**Re: Court Reference No. COR 2016 005084 – Sand Road & Princes Way
Intersection, Longwarry North**

Princes way & Sand Road Intersection, Longwarry North
Existing Conditions

Princes way & Sand Road Intersection, Longwarry North
Line marking changes

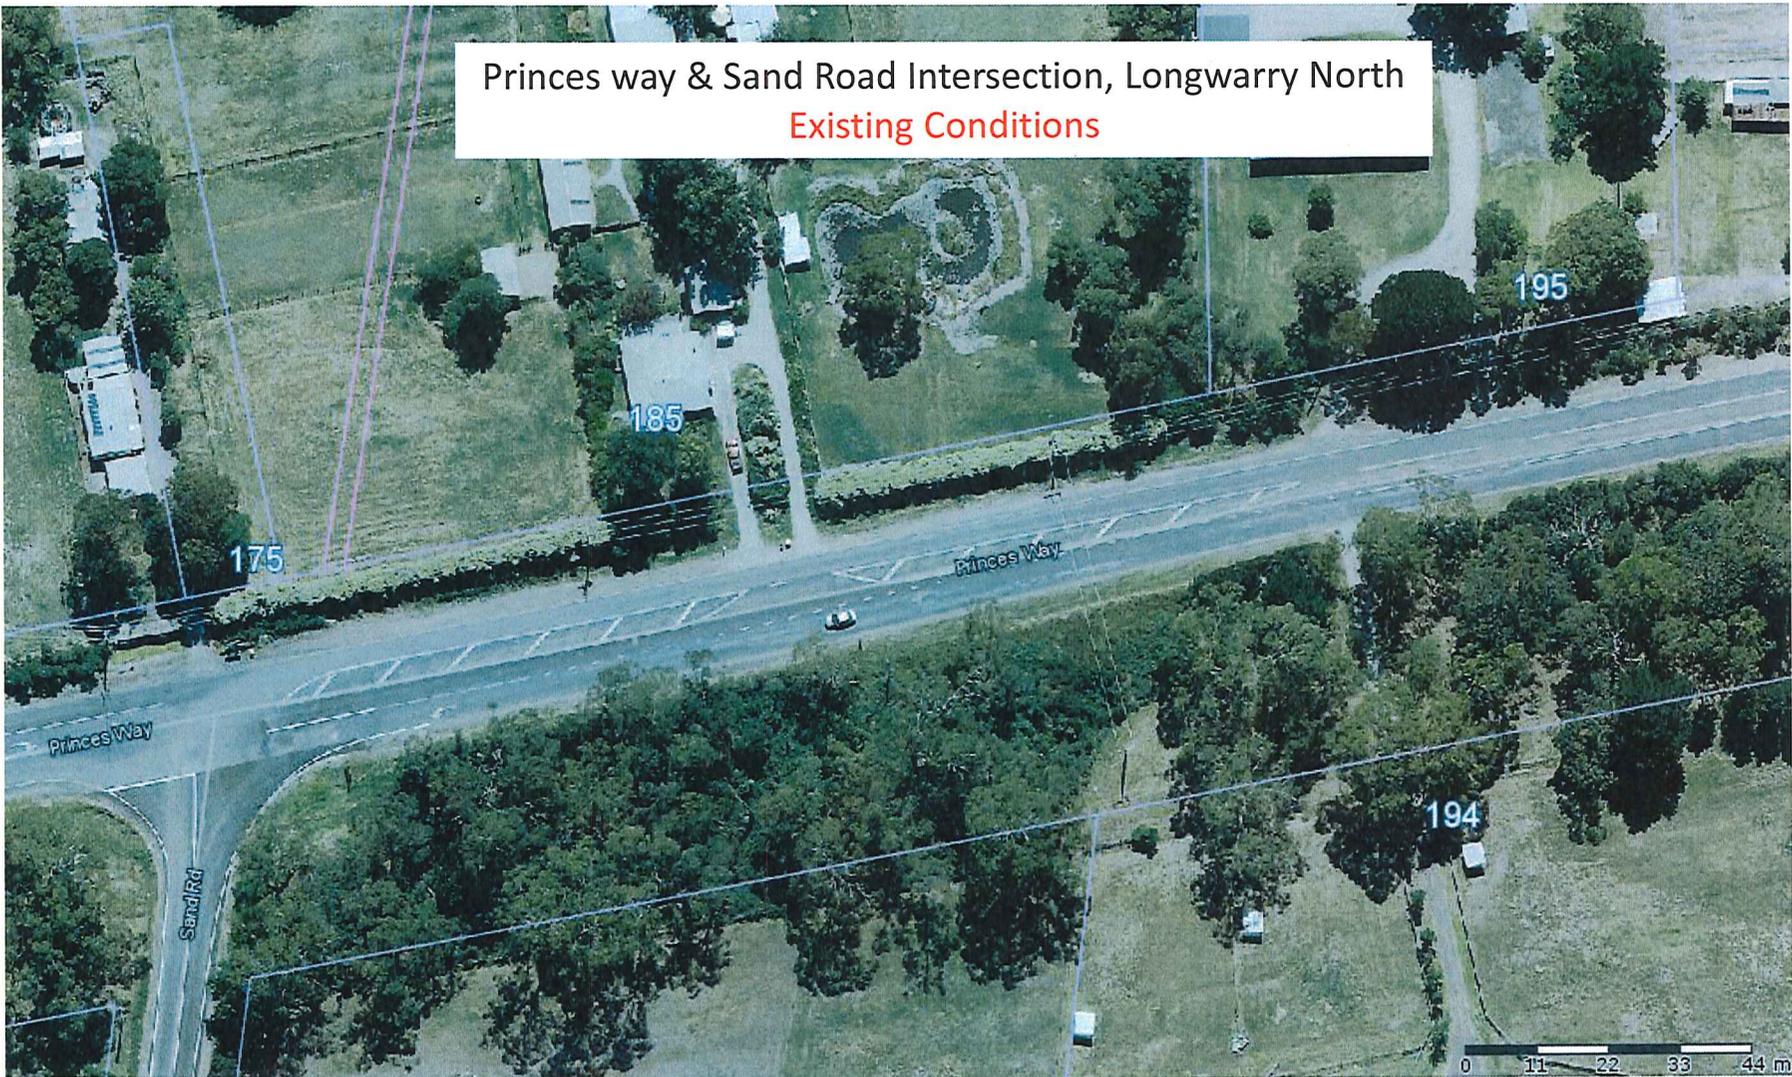
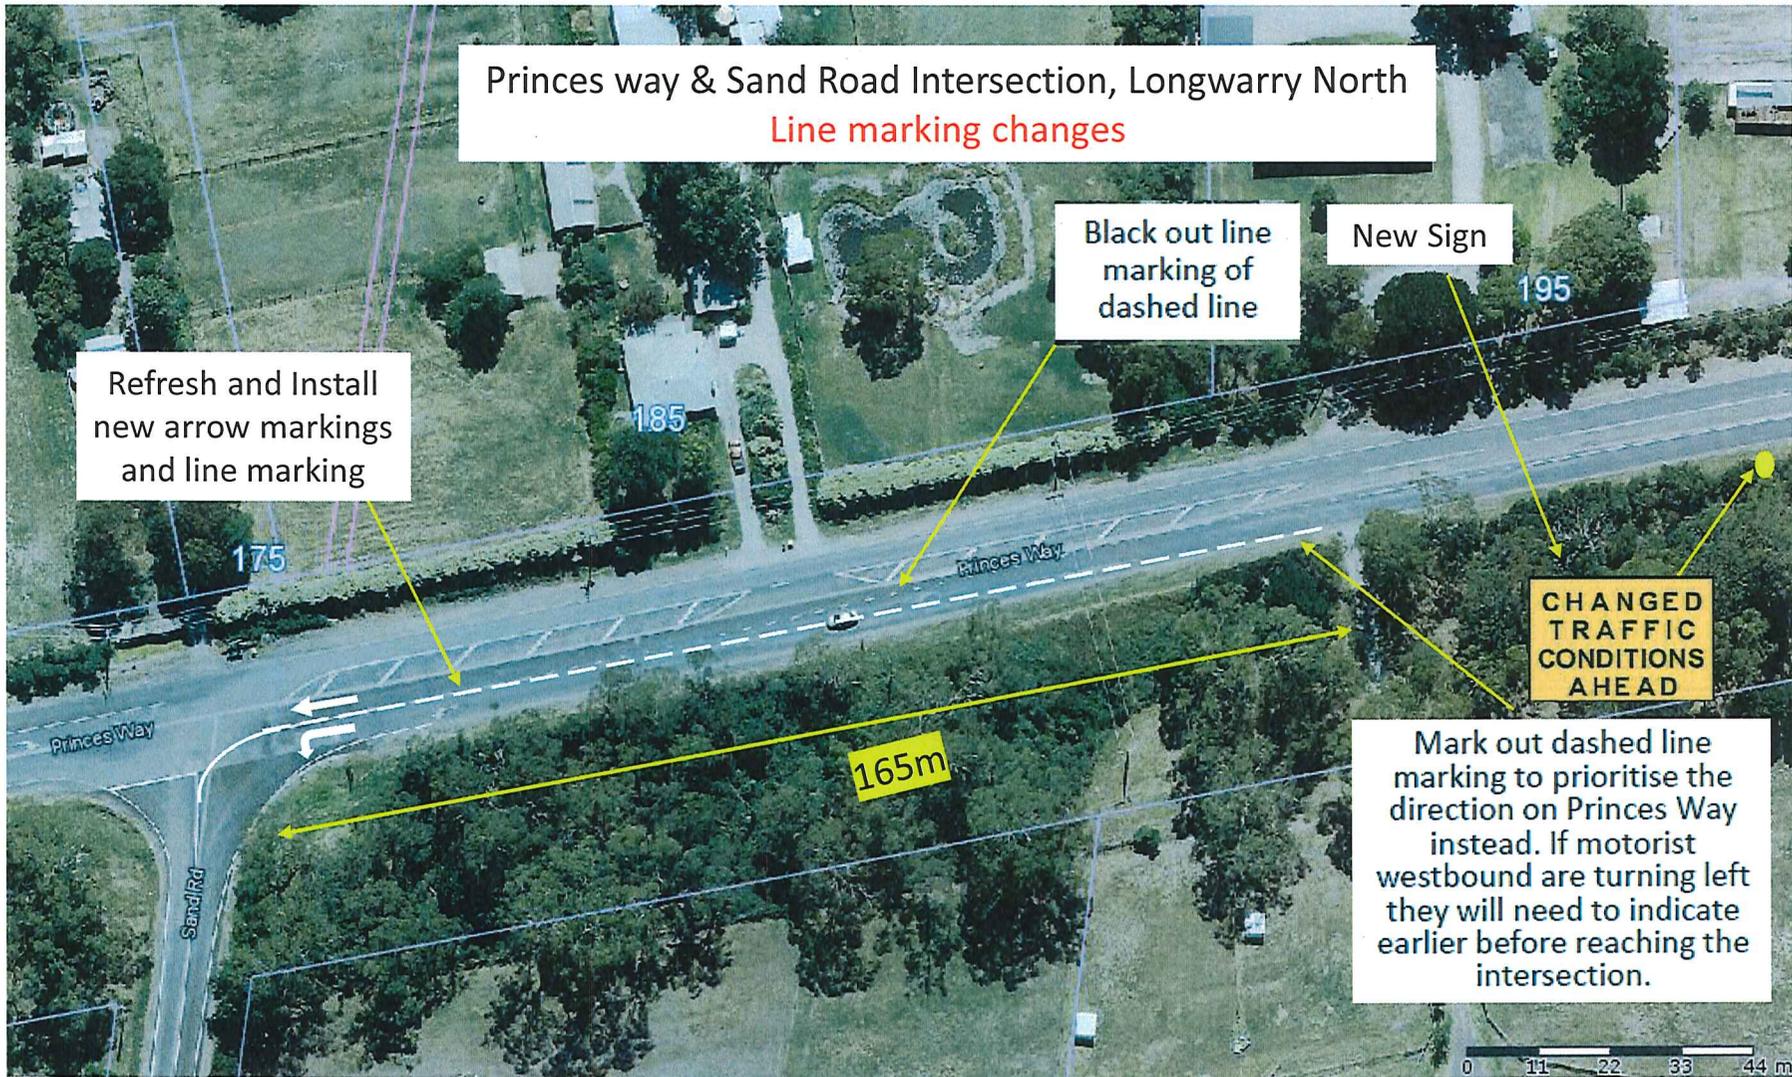
Refresh and Install new arrow markings and line marking

Black out line marking of dashed line

New Sign

CHANGED TRAFFIC CONDITIONS AHEAD

Mark out dashed line marking to prioritise the direction on Princes Way instead. If motorist westbound are turning left they will need to indicate earlier before reaching the intersection.
